Issue Number:	N172404	PDF Date Submitted	01/07/2005		
<input checked="" type="checkbox"/> Part - Location:	Ignition Key Cylinder Assembly -Column - Steering				
<input checked="" type="checkbox"/> Complaint:	vehicle can be keyed off with knee while driving				
Issue Type:	Current Prod	Vehicle/Product Line:	3Acar		Region:
<input checked="" type="checkbox"/> Severity:	3	Primary Metric/Score:	LaunchX / 0.025

GMX001 Lock Module Detent in RUN

Containment Solution

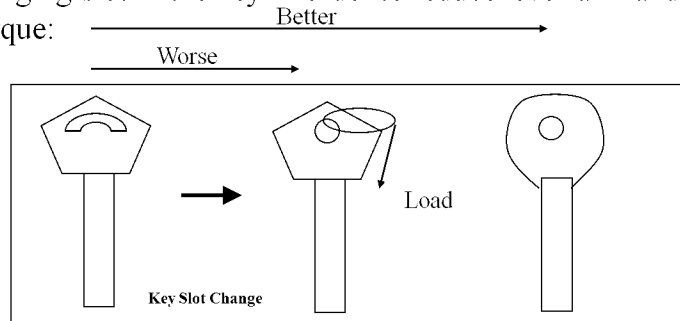
➤ Changing slot in the key in order to reduce lever arm and thus the torque:

✓ It was determined that the lever arm is still present due to fob ring. This may even cause a higher pulling load if fob ring is wedged between the slot and the sharp corner of key.

✓ Can be considered as a containment if the shape of key is changed to round corners

Partial Solution Design Concept

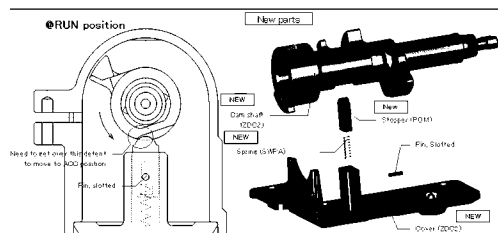
➤ Detent between lock cover and cam shaft:

- ✓ Partial solution based on engineering judgment. No experimental verification that detent is sufficient.
- ✓ If chosen, will drive changes and tuning efforts in ignition switch in order to avoid double detent feel.
- ✓ Design has to become common between Delta, Theta and Kappa
- ✓ Can be combined with the new ignition switch presently sourced for GMT191/2/3 for better detent
